SUTPHEN CORPORATION

SALES TECHNICAL BULLETIN

CHEVRON STRIPING – REAR BODY

#018 YELLOW

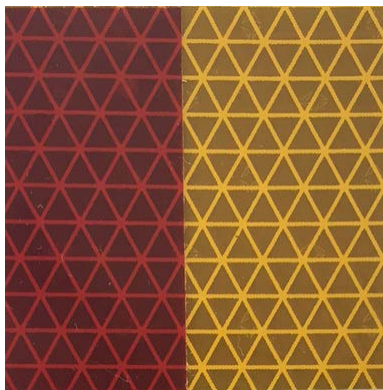
ORAFOL REFLEXITE V98 (NEW OFFERING!)

Due to the issues we have seen with the 3M Diamond Grade, Sutphen went in search of a suitable replacement offering. We are pleased announce a new offering of Orafol Reflexite. Orafol is a large supplier to the fire/EMS industry and offers, what we feel, is a product that is much better suited to our application. The Reflexite material is much thinner and much more pliable than the 3M Diamond Grade material. It is also not subject to the same discoloration resulting from an impact.

Orafol offers three different colors of Reflexite that meet the requirements of NFPA. Those colors are #018 YELLOW, #L1 FLUORESCENT YELLOW, and #L2 FLUORESCENT GREEN. Each will have #031 transparent red film overlay. The #018 yellow closely matches the 3M Diamond Grade #3991 yellow and the #L2 fluorescent green closely matches the 3M Diamond Grade #3983. It is hard to tell the difference unless the materials (or apparatus) are directly side-by-side.

**#L1 FLUORESCENT
YELLOW**

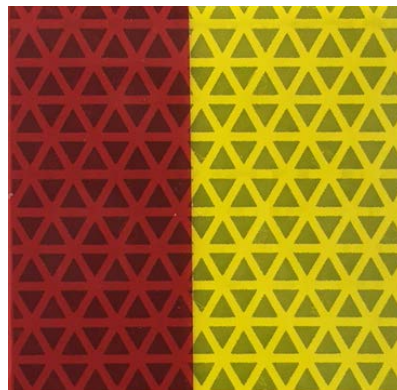
Below are samples of the three different Reflexite offerings with the transparent red overlay:
